Access Compliance Report

Public Rights-of-Way

(Pedestrian Signals)

Intersection ID: N/A	Main Street:	Cross Street: N/A	Location: N/A
ADA ID: 159C90B943CA	Signal Type: One Push Button-APS	Overall Compliance: No	Severity Score: BTN 1: N/A BTN 2: N/A No BTN: N/A
Codes/Mitigation Info/Possible Solution		Field Measurements/Component Compliance

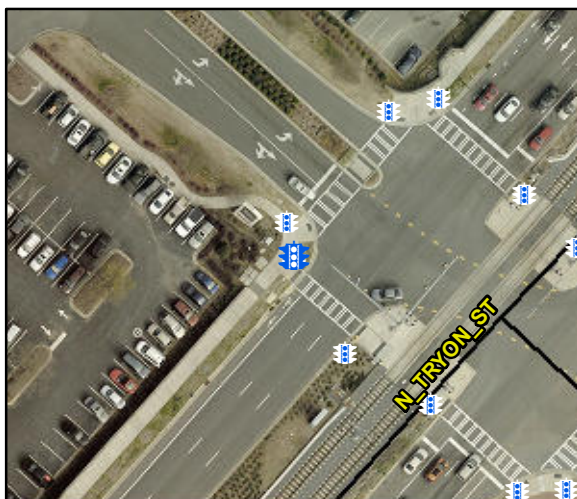
Compliance	Description	Data	Compliance	Description	Data
	Button Count	Button1	Yes	Distant to Additional Button (in)	363.0
	Additional Button Present?	Yes		Additional Button ID	E912077A626D
N/A	Signal Buttons Required?	N/A	N/A	Additional Ped Posts Required	N/A
	How Many Ped Street Xings?	N/A		Located In An Island/Median?	N/A
N/A	B 1 Sign Present?	Yes	N/A	B 2 Sign Present?	N/A
Yes	B 1 Sign Purpose?	Yes	N/A	B 2 Sign Purpose?	N/A
Yes	B 1 Sign Lettering & Contrast?	Yes	N/A	B 2 Sign Lettering & Contrast?	N/A
Yes	B 1 Parallel To XWalk?	Yes	N/A	B 2 Parallel To XWalk?	N/A
Yes	B 1 PAR to Button?	Yes	N/A	B 2 PAR to Button?	N/A
Yes	B 1 PAR to XWalk?	Yes	N/A	B 2 PAR to XWalk?	N/A
Yes	B 1 Clear Floor Space?	Yes	N/A	B 2 Clear Floor Space?	N/A
N/A	B 1 FWD Approach?	No	N/A	B 2 FWD Approach?	N/A
N/A	B 1 FWD Approach Constrained?	N/A	N/A	B 2 FWD Approach Constrained?	N/A
N/A	B 1 FWD Approach Reach (in)	N/A	N/A	B 2 FWD Approach Reach (in)	N/A

N/A	B 1 FWD Approach Width (in)	N/A	N/A	B 2 FWD Approach Width (in)	N/A
N/A	B 1 FWD Approach Obstruction?	Yes	N/A	B 2 FWD Approach Obstruction?	N/A
N/A	B 1 FWD Approach Obstruction Dist (in)	4.0	N/A	B 2 FWD Approach ObstructionDist (in)	N/A
N/A	B 1 PARA Approach?	Yes	N/A	B 2 PARA Approach?	N/A
N/A	B 1 PARA Approach Constrained?	Yes	N/A	B 2 PARA Approach Constrained?	N/A
No	B 1 PARA Approach Reach (in)	17.0	N/A	B 2 PARA Approach Reach (in)	N/A
No	B 1 PARA Approach Width (in)	48.0	N/A	B 2 PARA Approach Width (in)	N/A
N/A	B 1 PARA Approach Obstruction?	Yes	N/A	B 2 PARA Approach Obstruction?	N/A
N/A	B 1 PARA Approach Obstruction Dist (in)	5.0	N/A	B 2 PARA Approach ObstructionDist (in)	N/A
No	B 1 Clear Floor Space Slope (%)	4.6	N/A	B 2 Clear Floor Space Slope (%)	N/A
No	B 1 Clear Floor Space XSlope (%)	5.1	N/A	B 2 Clear Floor Space XSlope (%)	N/A
N/A	B 1 PAR Slope (%)	N/A	N/A	B 2 PAR Slope (%)	N/A
Yes	B 1 Height (in)	39.0	N/A	B 2 Height (in)	N/A

Possible Solutions: Remove & Replace
Replace APS Button With New APS Button.
Remove and Replace Clear Space.
